ECE/TRANS/WP.29/GRE/2009/48 16 July 2009

COLLECTIVE AMENDMENTS

Proposal for draft 04 series of amendments to Regulation No. 19 (Front fog lamps)

Submitted by the expert from the Working Party "Brussels 1952" */

Summary of the Transitional Provisions in the above proposal to amend Paragraph 14 of Regulation 19.

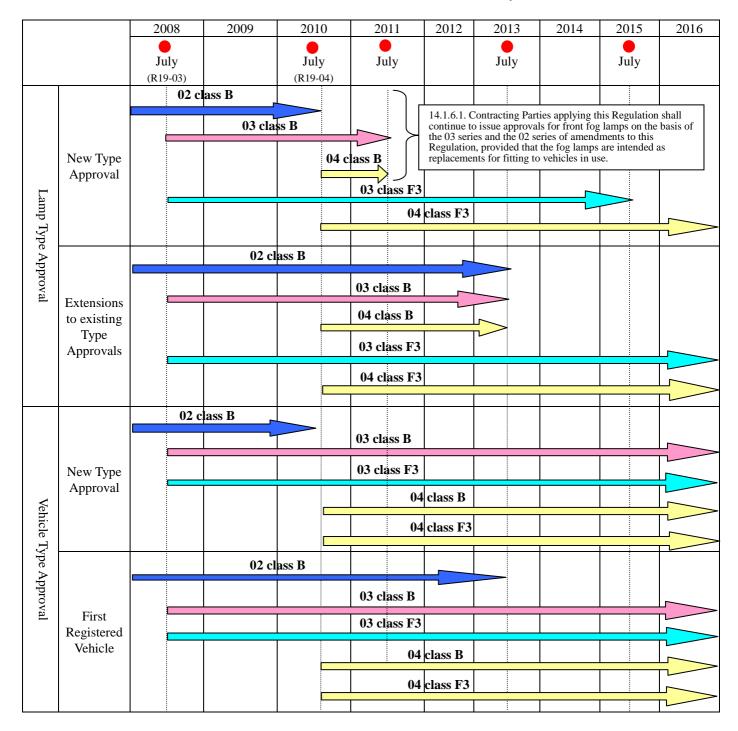
- "14. TRANSITIONAL PROVISIONS
- 14.1. In the case of Class B front fog lamps:
- 14.1.1. From the date of entry into force of the **04** series of amendments to this Regulation no Contracting Party applying it shall refuse to grant approvals under this Regulation as amended by the 02 or 03 series of amendments. **Existing approvals and extensions of these approvals remain valid indefinitely.**

- 14.1.2. As from 24 months after the date of entry into force of the 03 series of amendments, Contracting Parties applying this Regulation shall grant approvals only if Class B front fog lamps meet the requirements of this Regulation as amended by the 03 **or 04** series of amendments.

- 14.1.3. As from 36 months after the date of entry into force of the 03 series of amendments, Contracting Parties applying this Regulation shall grant approvals for a new type of front fog lamp only if front fog lamps meet the requirements of Class F3 of this Regulation as amended by to the 03 series of amendments.

- 14.1.4. Existing approvals for front fog lamps already granted under this Regulation before the date of entry into force of the 03 series of amendments shall remain valid. However, after the date of entry into force of the 03 series of amendments, Contracting Parties applying this Regulation may prohibit the fitting of front fog lamps equipped with filament lamps unless they satisfy the requirements of Regulation No. 37.

- 14.1.5. Contracting Parties applying this Regulation may prohibit the fitting of devices, which do not meet the requirements of the 03 or 04 series of this Regulation:

- 14.1.5.1. on vehicles for which type approval or individual approval is granted more than 24 months after the date of entry into force of the 03 series of amendments.

- 14.1.5.2. on vehicles first registered more than 60 months after the date of entry into force of the 03 series of amendments
- 14.1.6. As from 60 month after the date of entry into force of the 03 series of amendments, Contracting Parties applying this Regulation shall refuse to grant any extensions of approvals if the front fog lamps do not meet the requirements of Class F3 of this Regulation as amended by the 03 series of amendments.

- 14.1.6.1. Contracting Parties applying this Regulation shall continue to issue approvals for front fog lamps on the basis of the 03 series and the 02 series of amendments to this Regulation, provided that the fog lamps are intended as replacements for fitting to vehicles in use.

- 14.2. In the case of Class F3 front fog lamps:
- 14.2.1. From the date of entry into force of the 04 series of amendments to this Regulation, no Contracting Party applying it shall refuse to grant approvals, under this Regulation as amended by the 04 series of amendments. Existing approvals and extensions of these approvals remain valid indefinitely.

- 14.2.2. As from 60 months after the date of entry into force of the 04 series of amendments, Contracting Parties applying this Regulation shall grant approvals only if Class F3 front fog lamps meet the requirements of this Regulation as amended by the 04 series of amendments."
